Randwick Local Planning Panel (Electronic) Meeting

Thursday 8 February 2024

Development Application Report No. D2/24

Subject: 10 Major Street, Coogee (DA/3/2023)

Figure 11: Revised ground floor plan in PL/39/2021 – 10 Major Street, Coogee (Source: Ken Powell Architect)

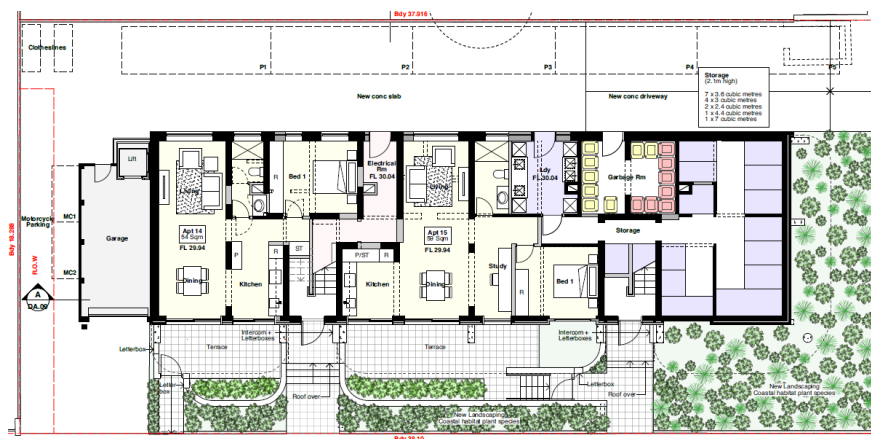
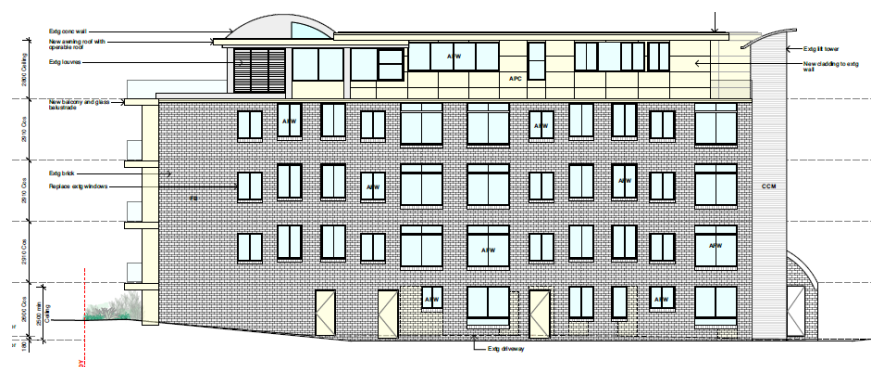
On 03 December 2021, Council received amended architectural plans that addressed some of the concerns above. The amended proposal was referred to the Randwick Design Excellence Advisory Panel (DEAP) for additional comments. Snippets showing the amended architectural plans have been reproduced below:

Figure 21: Proposed western elevation with Council markings in red – 10 Major Street, Coogee (Source: Ken Powell Architect)

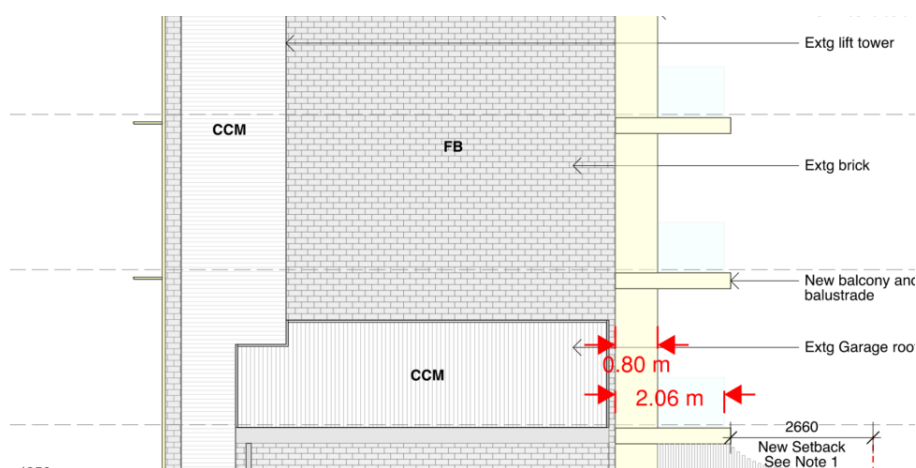
Notwithstanding, Council is concerned that the first, second and third floor southern balconies to Units 1, 3 and 5 will further overlook the eastern bedroom window of 4/58 Arcadia Street to the west. It is noted that the existing balconies currently overlook this window (see Figure 20 below).

The proposed balconies will be extended in width from 1.29m to 2.28m, being 990mm wider. In addition, along the western side of each balcony adjoining the southern façade wall will be an 800mm wall section for structural support. See Figure 21 below.

Whilst the angle of overlooking is more acute than the existing, the impact is similar to the existing on site. In order to address these overlooking concerns from the extended balconies, a condition of consent will be issued requiring that privacy screens measuring a height of 1.6m are to be installed to the western sides of the southern balconies to Units 1, 3 and 5. In order to integrate into the design of the proposed building and reduce the visual impact they will have on the foreshore area, a condition of consent will be issued requiring that the privacy screens are to be installed with translucent or obscured glazing to a height of 1.6m from the FFL of the balconies. Subject to these conditions, Council is satisfied that visual privacy to these sensitive rooms have been addressed. It is noted that such privacy screens will have a minimal impact upon view corridors from No. 4/58 Arcadia Street to the east of the ocean. See view sharing assessment below for full details and considerations.

Figure 21 & 22: Proposed section and southern elevation with notations from Council's Design Excellence Panel – 10 Major Street, Coogee (Source: Ken Powell Architect)

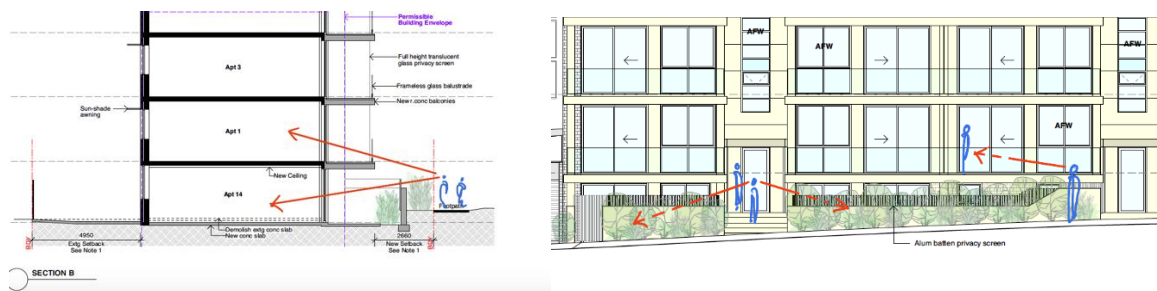
In terms of privacy into the first floor units from public spaces, the DEAP provided comments which have been reproduced below:

Furthermore, the kitchen and living spaces are directly overlooked by the street and common entry... The upper-level apartments are too exposed to the street and park, each level shows floor-to-ceiling glass and completely glazed balconies. A better solution would include a greater degree of shielding through at least partially solid balustrades to these balconies.

The applicant has provided the following response to the issues raised by the DEP:

Figure 1 - Existing Parking Layout

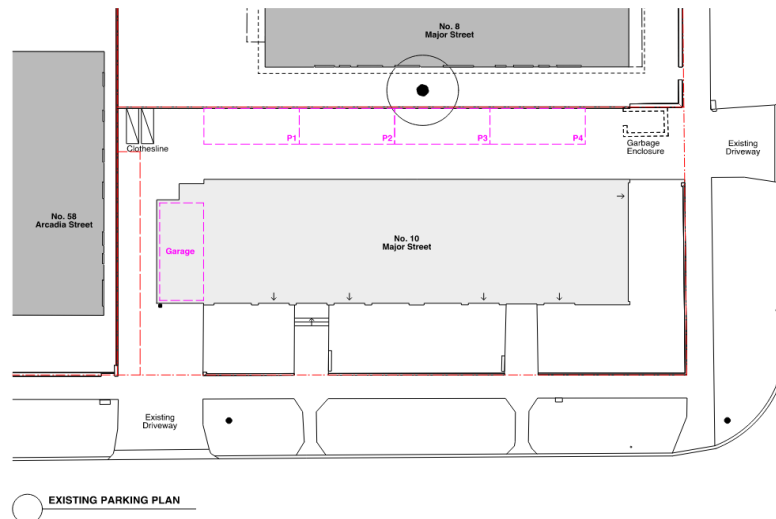
The present configuration includes 4 spaces provided on the internal driveway parallel and adjacent to the northern side boundary plus 1 space within the existing garage accessed from Arcadia Street being a total of 5 spaces (see below)

Upon site inspection it was observed that vehicles parked in the spaces adjacent to the northern boundary were facing Major Street implying the vehicles entered the site from Arcadia street and then drove around the rear of the garage, effectively creating a one way traffic movement system through the site from Arcadia St to Major St. Alternatively it may have been possible that vehicles are reversing down the driveway from Major Street or undertaking point turns at the end of the aisle.

Figure 2 - Proposed Parking Layout

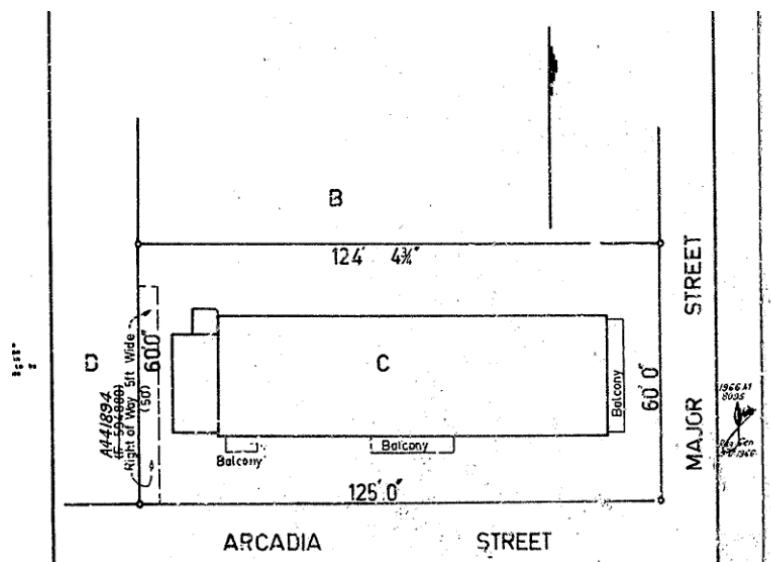
It is Development Engineering's preference that vehicles generally exit the site from Major Street in a forward direction, which would require them to reverse in. An operational condition enforcing this requirement was considered however this would be difficult to enforce and is inflexible. The site's residents have been living with this configuration for a long period of time and Council has not received any complaints on driver behaviour at this property.

The final configuration is a reasonable compromise and will adequately provide for any additional parking demand. No further objections are raised.

Figure 10: Markup of proposed ground floor plan – maximum patron capacity

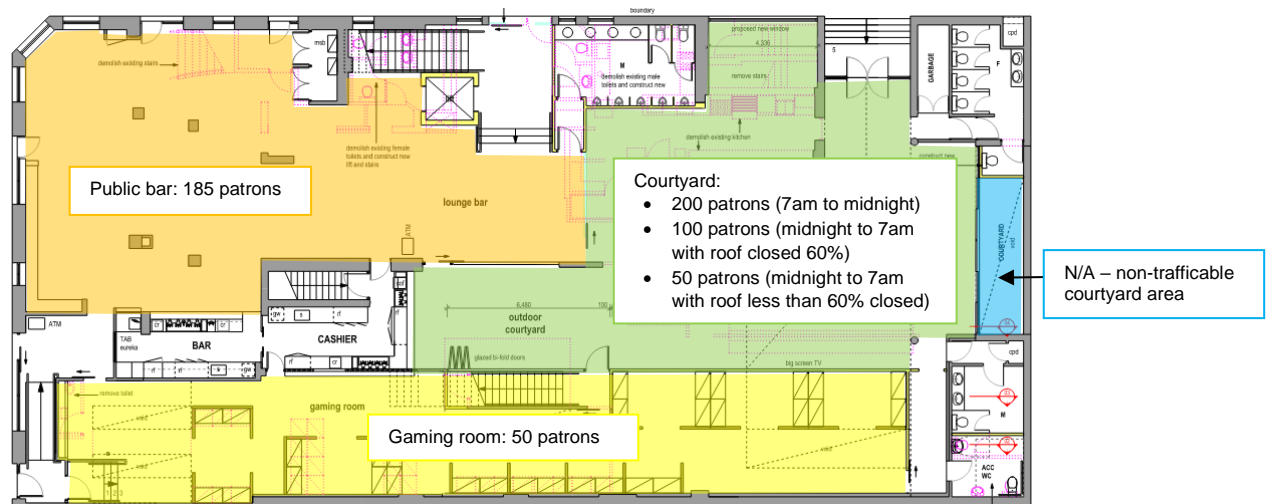
Figures 10 and 11 identify the proposed patron capacity numbers.

Council's Environmental Health Officer has reviewed the submitted Acoustic Report and raises no concern, subject to a reviewable condition relating to patron capacity.
